PROJECT: **F20-06 Single Point Entry – 2 Sites**
Kimbark ES and Parkside ES
DSA Application No. 04-118128 (Kimbark ES) and 04-118131 (Parkside ES)

RE: **ADDENDUM 2**

1 | LANDSCAPE AND IRRIGATION PLAN

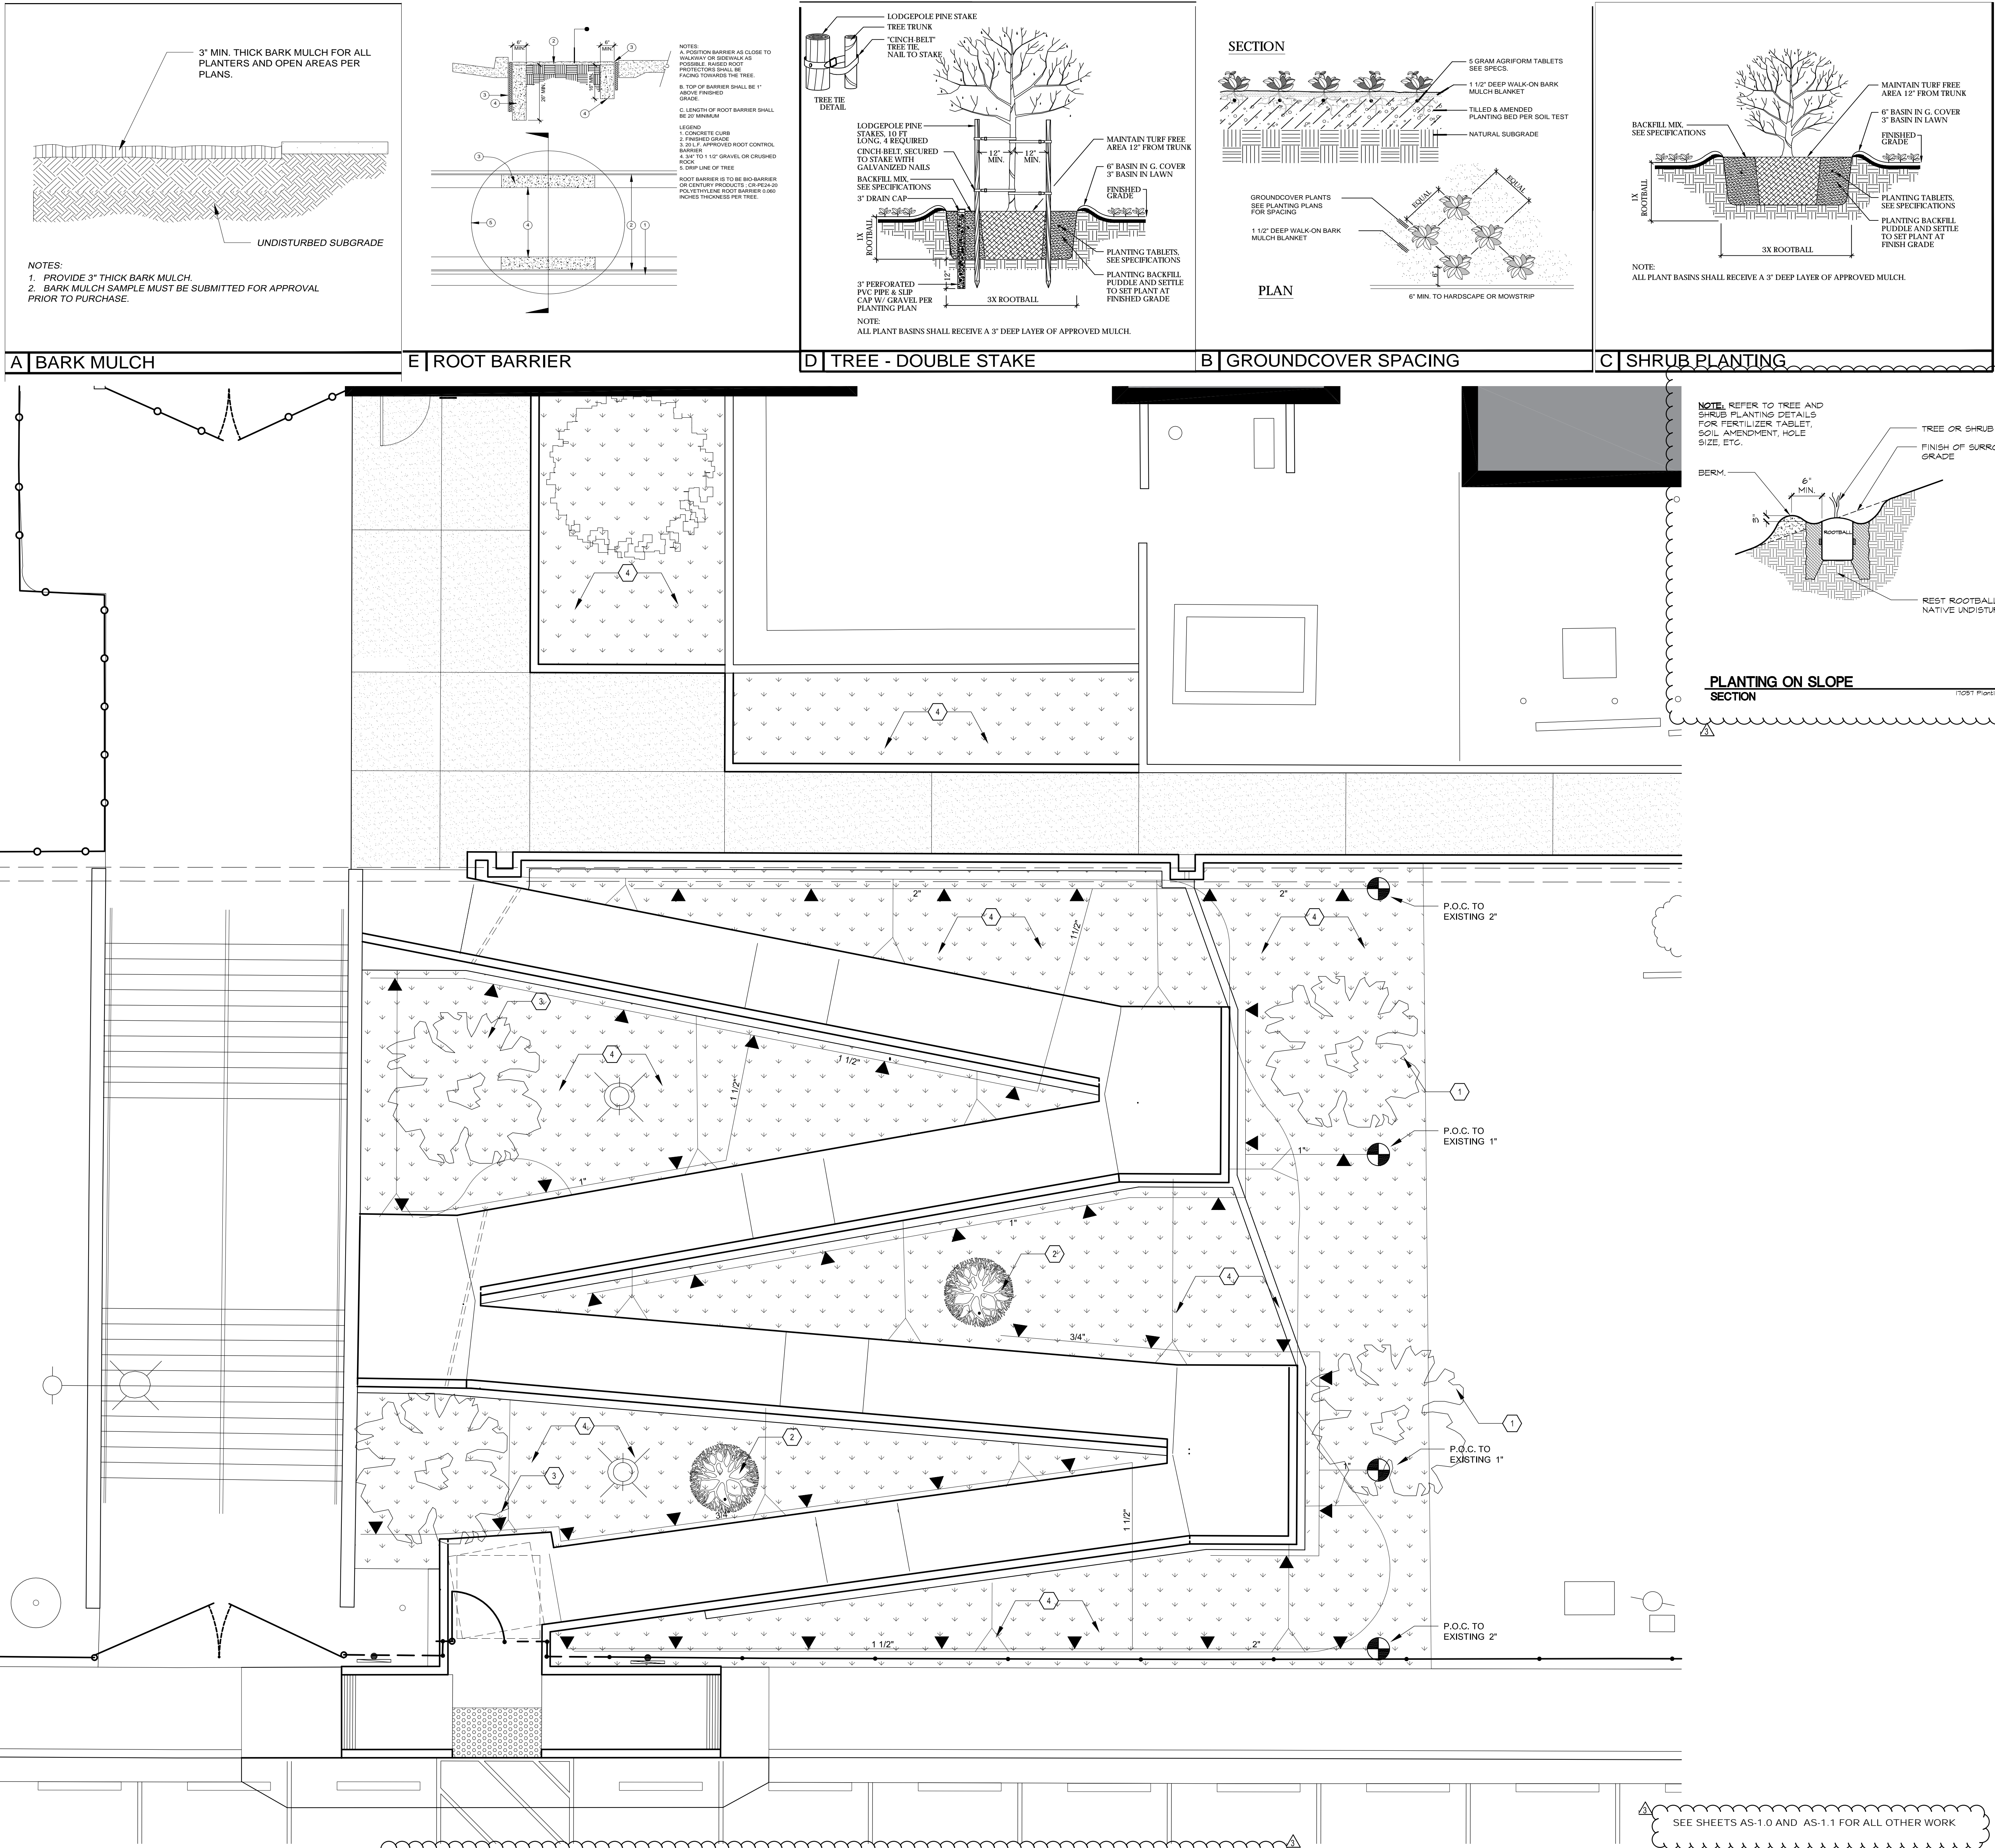
- 1.2 Replace Sheet AS1.5 LANDSCAPE PLAN with the sheet contained within this addendum.
 - 1.2.1 Change sheet name to Landscape/Irrigation Plan.
- 1.3 Replace Sheet A-1.0 FLOOR PLAN with the sheet contained within this addendum.
- 1.4 Replace Sheet A-1.1 INTERIOR ELEVATIONS with the sheet contained within this addendum.
- 1.5 Replace Sheet A-1.2 DETAILS/ELEVATION with the sheet contained within this addendum.
